## Submission to Western Harbour Tunnel and Warringah Freeway Upgrade EIS 30<sup>th</sup> March 2020

### Objection: Western Harbour Tunnel and Warringah Freeway Upgrade - SSI-8863

Anna Bragg  
President P&C  
Cammeray Public School P&C

## Appendix A: Construction Sites, Traffic and Schools

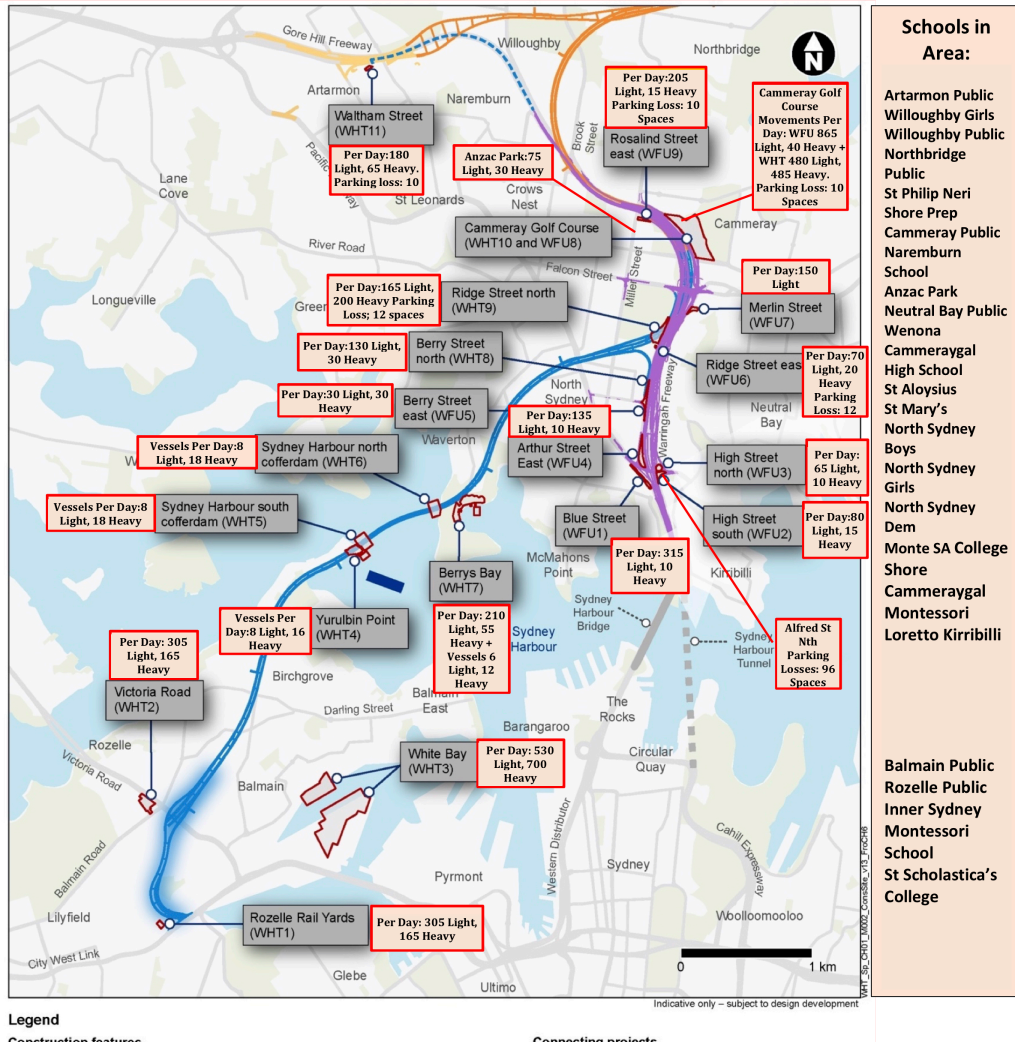
3. **Volume of Trucks on the Street:** Over the whole project there will be 6000+ construction movements per day needed. Most will operate between North Sydney and Willoughby where there will be 3045 vehicle movements at Cammeray Golf Course and 12 support sites. There is a large schedule of dangerous goods to be transported. This is an immense health and safety risk in residential areas full of children. Our children and families cross the busy roads of Brook St, Miller St and Amherst St to get to school and their safety must be considered. Many parents drop off, park and catch public transport into the city. This will become more difficult due competition with worker parking and the removal of 150 parking spaces across the North Shore. The area has already experienced a fatality with one construction vehicle. An illustration of sites, truck locations and location of schools is attached in [Appendix A](#).

1. **Volume of Trucks on the Street:** The bulk of vehicle movements will occur between North Sydney and Willoughby where there will be 3045 vehicle movements daily at the main Cammeray Golf Course and 12 support sites – with over 2000 close to or in Cammeray schools' catchment. This is an immense health and safety risk in residential areas full of children. Our children and families cross the busy roads of Brook St, Miller St and Amherst St to get to school and their safety must be considered. Many parents drop off, park and catch public transport into the city. This will become more difficult due competition with worker parking and the removal of 150 parking spaces across the North Shore and does not support the governments objectives of supporting a mode shift to public transport.

**Conditions of Approval must include:** a plan developed with North Sydney AND Willoughby Council to agree truck routes and contractor parking as a Condition of Approval. All parking must be accounted for and workers/ construction vehicles must be kept off Palmer St Bellevue St and other local roads used by children. Based on evidence (attached) that sensitive receivers are receiving the greatest increases and that future pollution will be above PM2.5, all buildings identified as eligible should be granted noise attenuation (especially schools and preschools such as Cammeray Public School), return the same amount of **usable** green space the community....polluted parks are not usable green space. The stack height (or filtration) needs to be reconsidered given the two-storey height and elevated position of schools like Cammeray and Neutral Bay (as per sensitivity analysis) Increasing the stack height however will have greater visual amenity impacts – filtering the stack would not necessitate an increase in height and may facilitate better visual outcomes for Cammeray and surrounding suburbs.

**Figure 12-22 Annual mean PM<sub>2.5</sub> concentration at community receivers**  
7 µg/m<sup>3</sup> legislated by 2025

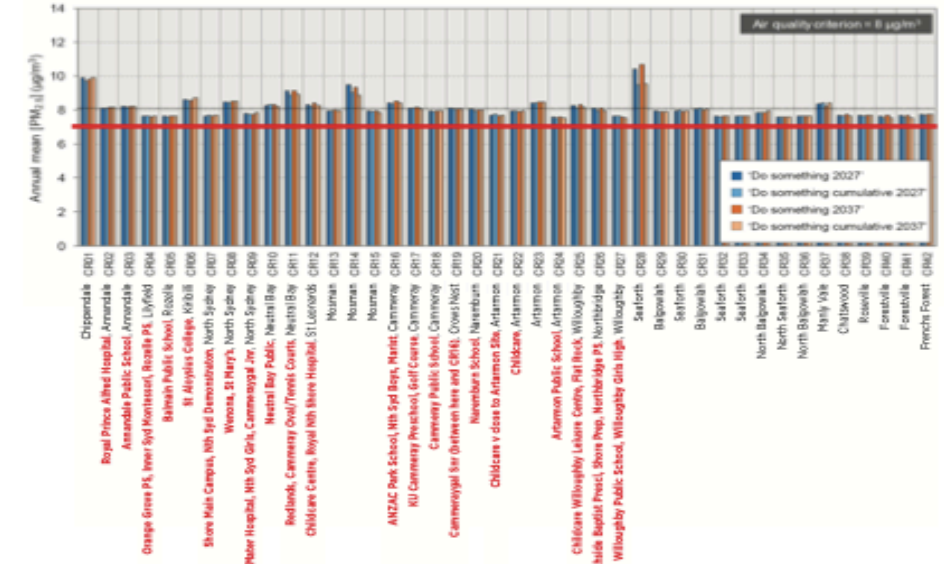
**Pollution:** (Here [for a summary table of pollution impacts](#)): The ventilation stack servicing the 6.5km stack at Cammeray will not be filtered. The EIS demonstrates concerning impacts in terms of pollution for CPS and its' catchment. All areas will see overall PM2.5 levels well about national criteria when project opens. CPS will experience increases in pollution across NO2, PM10 (annual) and PM2.5 (which WHO states no safe limit). Concerningly our local parks will also be impacted by increased pollution including Green Park, Cammeray Oval, St Leonard's Park and Bicentennial Reserve. Children are most susceptible, particularly at higher respiration rates. The stacks have no emergency ventilation outlets and so fumes from any high pollution events or emergencies will be dispersed over schools in the area. A summary of the CR sites that show an increase in pollution across both projects is attached. Air pollution has been averaged out across a wide span of CR sites which appear unrelated to the Western Harbour Tunnel. As no traffic analysis has been done on Willoughby Rd for example it is hard to claim Roseville is impacted. FOR WHT only relevant sites should be included in the analysis and results should be weighted by number of sensitive receivers. One graph has results covered by the key and the PM2.5 tables do not show the correct criteria level with criterion to be lowered by 2025. [Appendx B](#). Increased rat running due to ramp and accessibility changes will also re-distribute pollution to residential areas increasing the burden on sensitive receivers.

**Reissue:** the air quality analysis should be completed showing the actual risks to each school in the area (ie CR's should be weighted based on sensitive receiver) taking into account relative elevation and risk, clear information about which houses will have substratum acquisition should be published, reissue visual amenity pictures with clearer artists impressions showing actual buildings.
